TECO's Response to OPC's Third Set of
Interrogatories Nos. 51-149

**TAMPA ELECTRIC COMPANY
DOCKET NO. 20220048-EI
OPC'S THIRD SET OF
INTERROGATORIES
INTERROGATORY NO. 51
BATES PAGE: 1
FILED: MAY 25, 2022**

Substation Extreme Weather Hardening

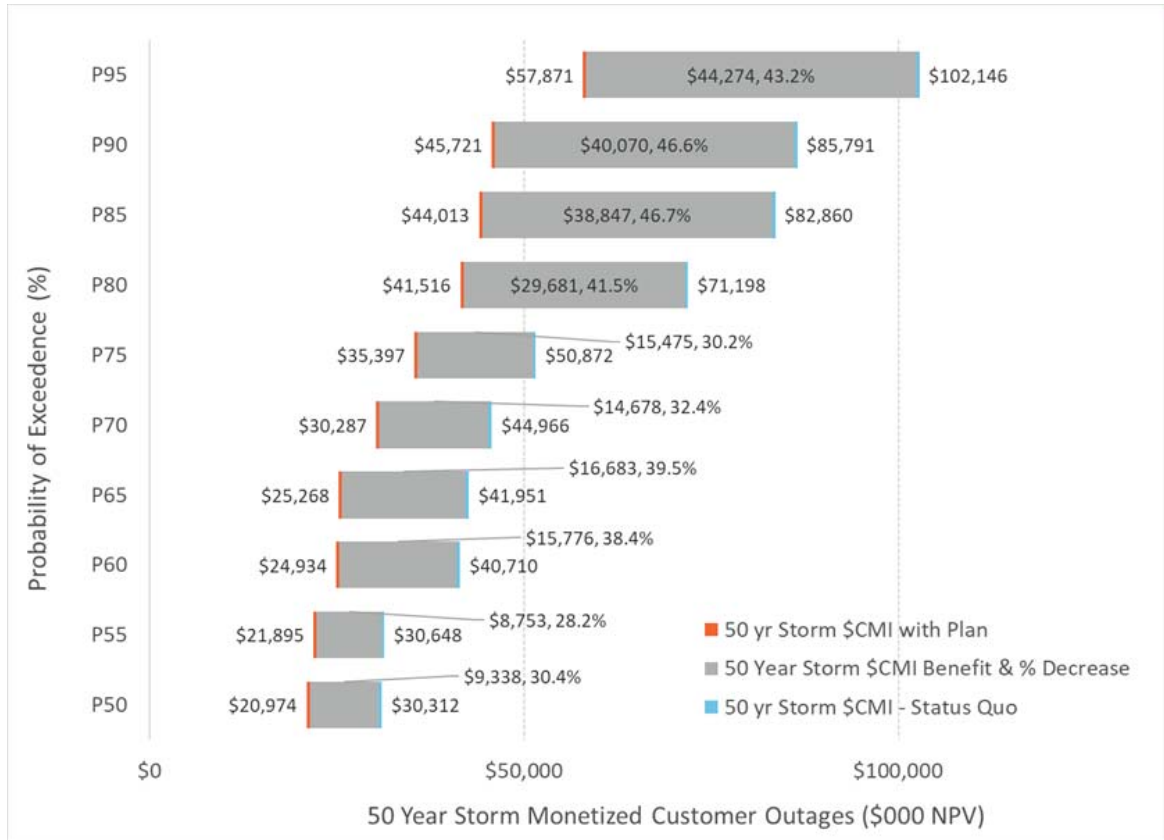
- a. Provide actual costs in reduction in restoration costs for storm protection program.
- b. Describe the term of reduction costs (annual, ten years, life of the assets, etc)
- c. Provided projected annual cost reduction for the next ten years.
- d. Provide actual customer minutes of interruption before improvements and after improvements.
- e. Describe the term of reduction costs (annual, ten years, life of the assets, etc)
- f. Provided projected annual cost reduction for the next ten years.

d. For each of the programs, the following figures shows:

The percentage in the grey areas map to the values in the table on page 71 of 78 references in the question. Adding all these figures together produces the results for the entire plan.

The following figures convert the CMI values to dollars using the DOE ICE Calculator and described in the plan.

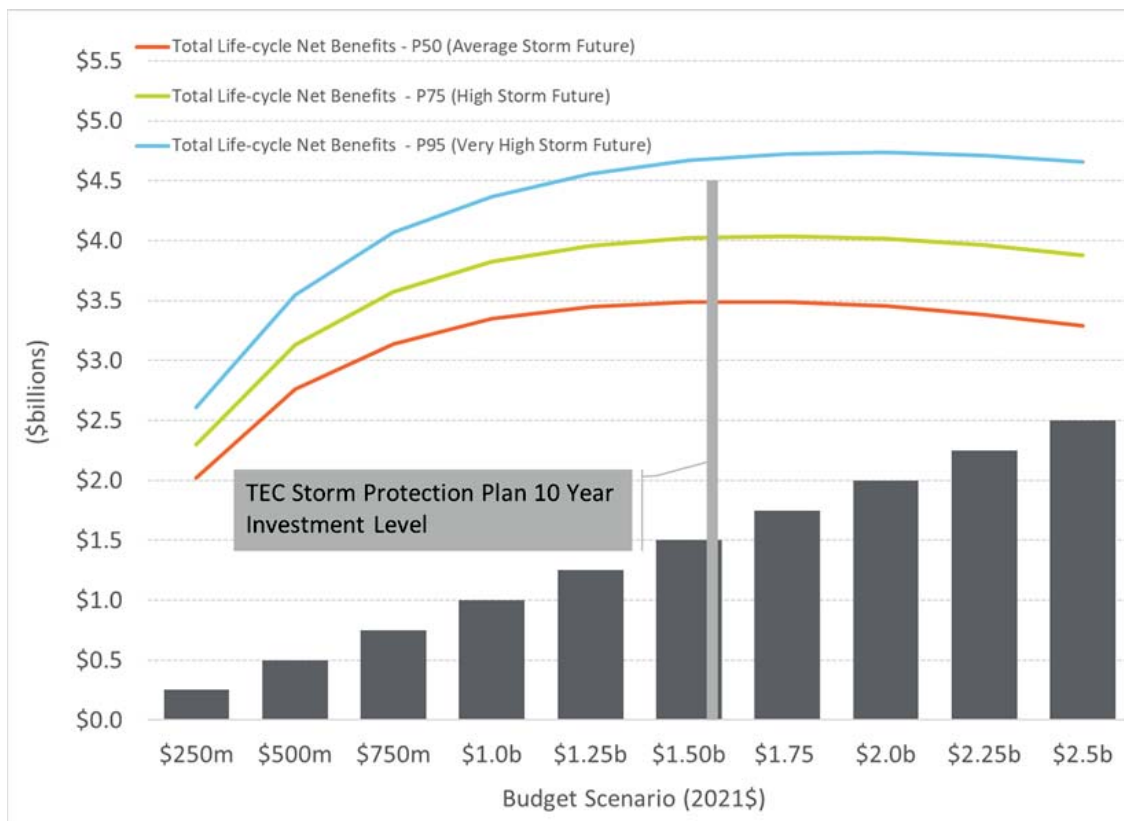
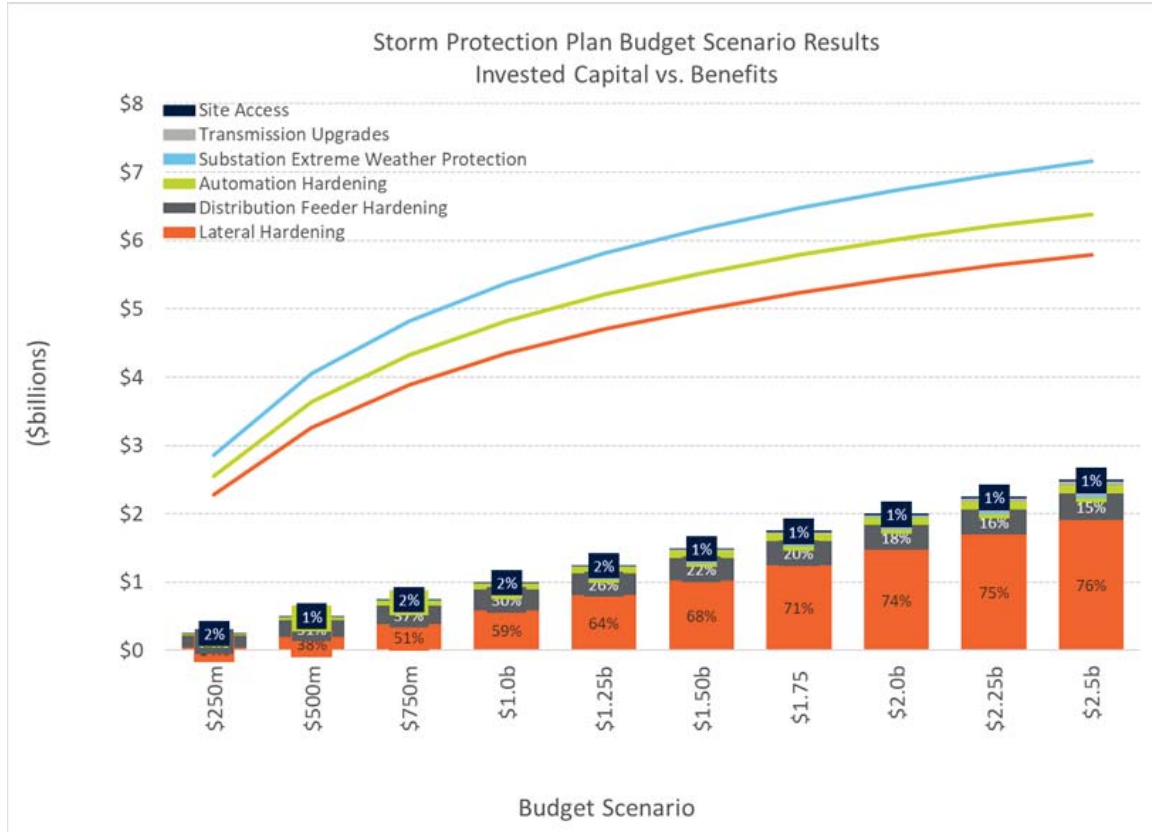
135. Referring to Exhibit DAP-1, page 77 of 78, provide detail results of the budget optimization analysis.

A. The 1898 & Co. Report includes additional information on the budget optimization analysis. Please see Exhibit DAP-1, Appendix F, page 70 of 82, section 6.0 Budget Optimization and Project Selection. Please note that the first figure includes the Net Benefits while the second figure includes the Gross Benefits. Net Benefits = Gross Benefits – Invested Capital

Monetized Outage Costs: Residential Customers

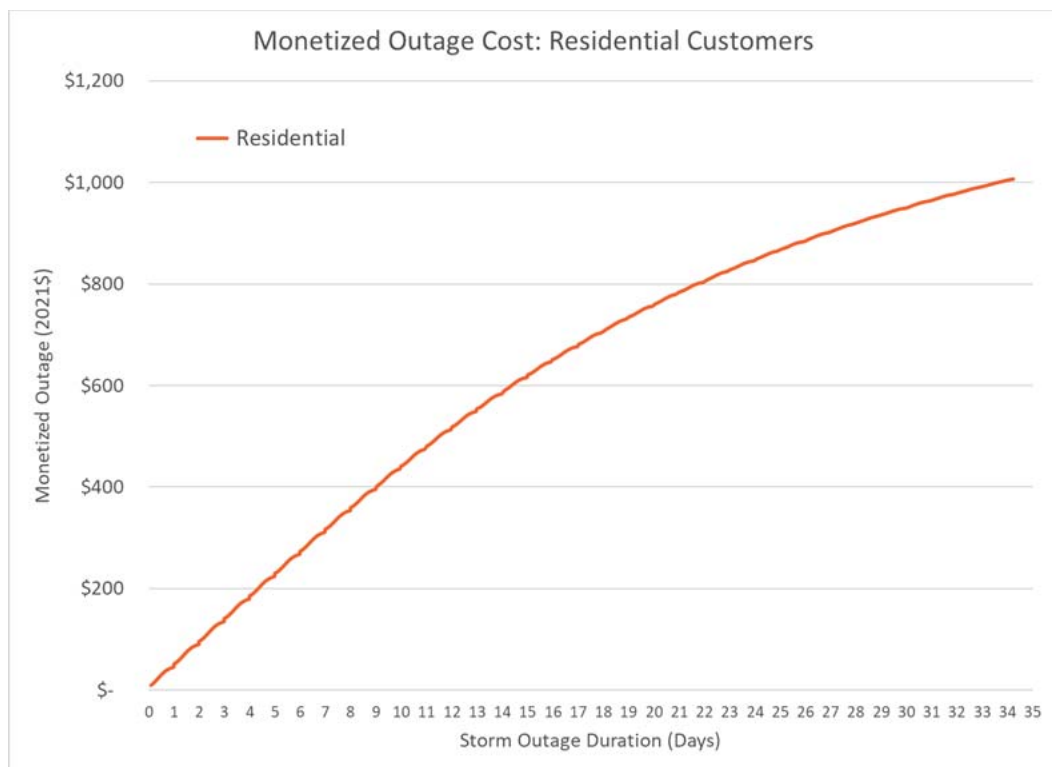
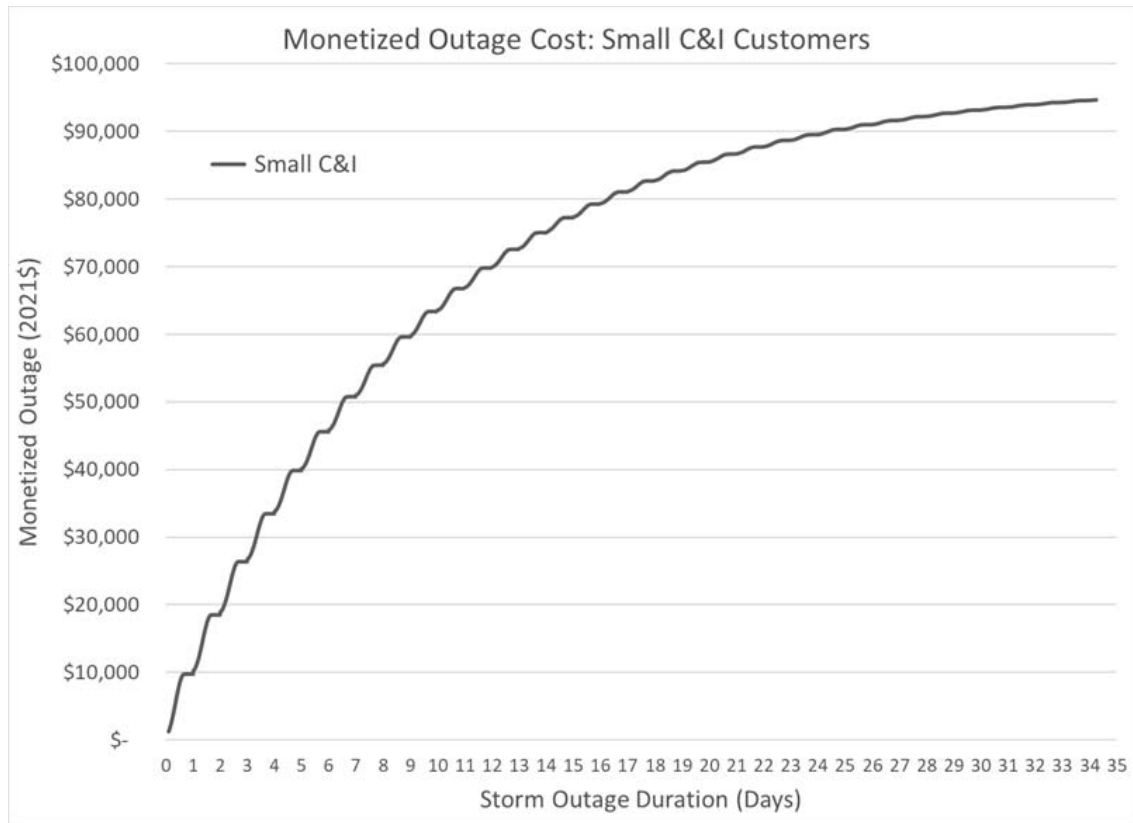
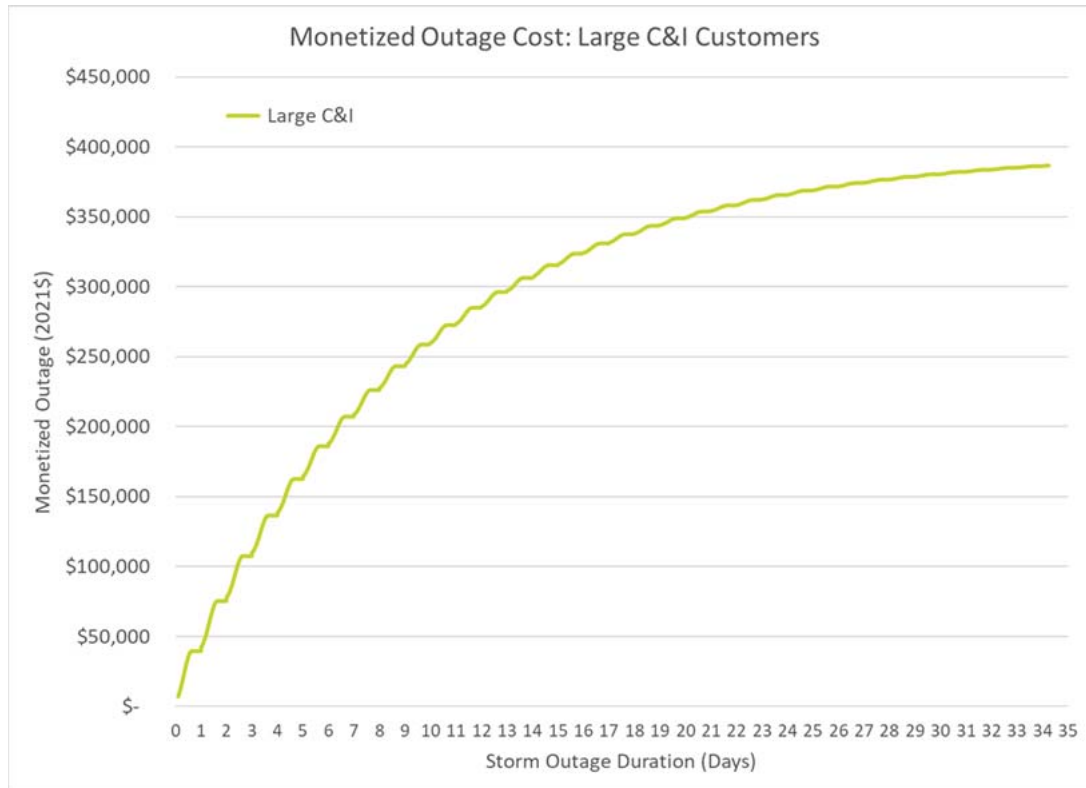
- a. Provide the annual frequency of storms
- b. Provide values used to input in the ICE calculator
- c. Provide individual results from the ICE calculator for the scenarios investigated.

Calculator results are done for each of the 13,350 for 99 different storm scenarios (~1,335,000 calculations). The approach also factors in customer counts and types (residential, Small C&I, Large C&I, critical) for each of the projects.

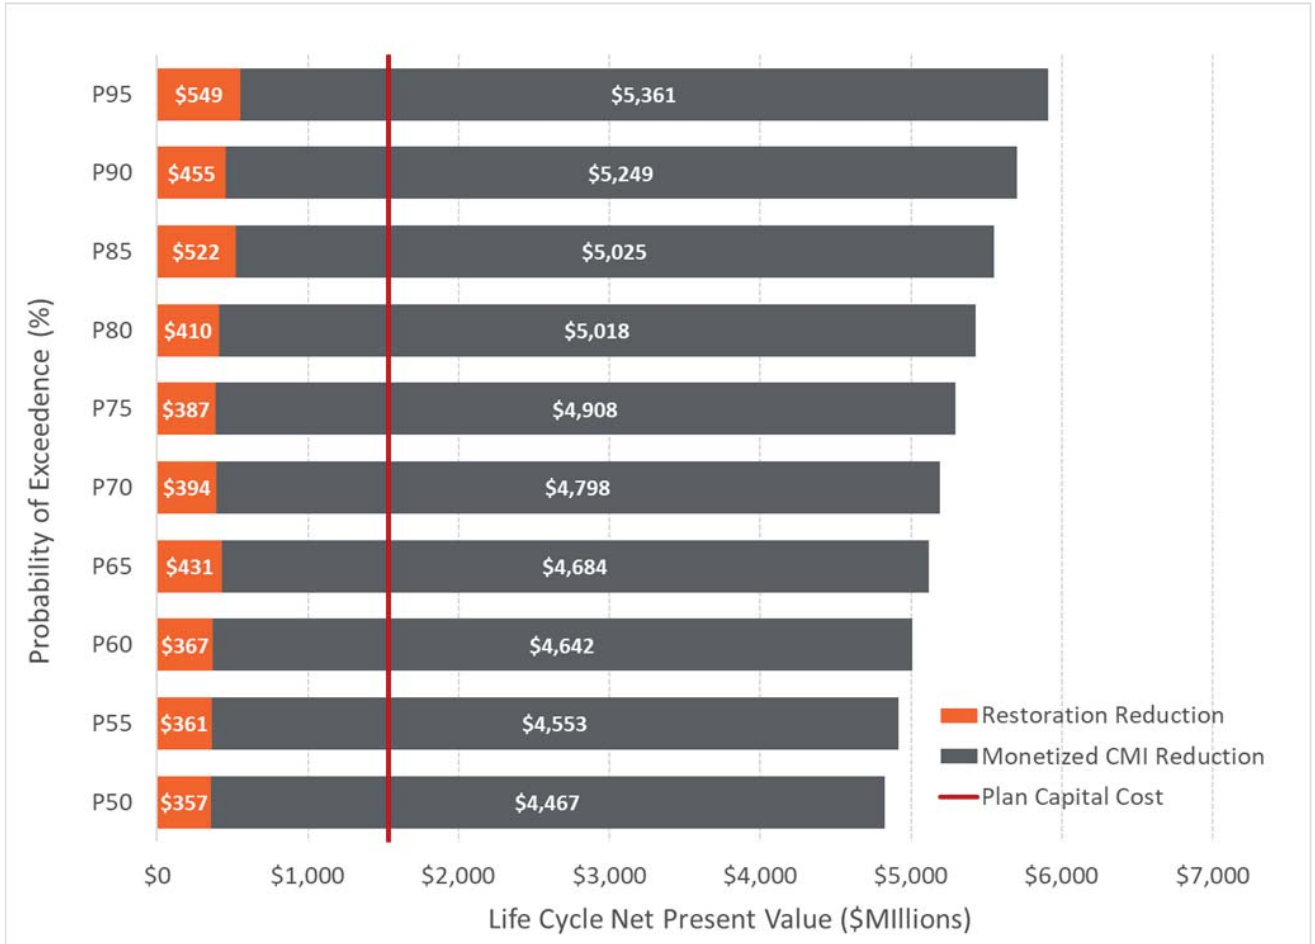
144. Regarding Exhibit DAP-1, Appendix F page 75 of 82, for a P70, the status quo would cost \$1.063 Billion to restore power and only \$0.645 billion to restore power if the full plan is implemented at a cost of \$1.594 billion, saving roughly \$0.418 billion in restoration costs. Please confirm this interpretation of the graph.

A. The interpretation is correct for the restoration cost benefit. However, the investment of \$1.594 billion would also produce a decrease in CMI which is shown in figure on the following page, Appendix F page 76 of 82. Using the P70 value, the investment of \$1,594 billion would provide benefits of:

Put another way, the cost to buy down 1,570 million CMI is \$1.113 billion (\$1.594 - \$0.481). As discussed in the SPP filing and the 1898 & Co. report, the business justification is the avoided restoration costs and CMI shown above. The report also includes the monetization of the CMI using the DOE ICE Calculator modified for longer outage times. The figure below shows an alternative business justification using that outage monetization approach. As this figure shows, the benefits outweigh the costs of the plan.
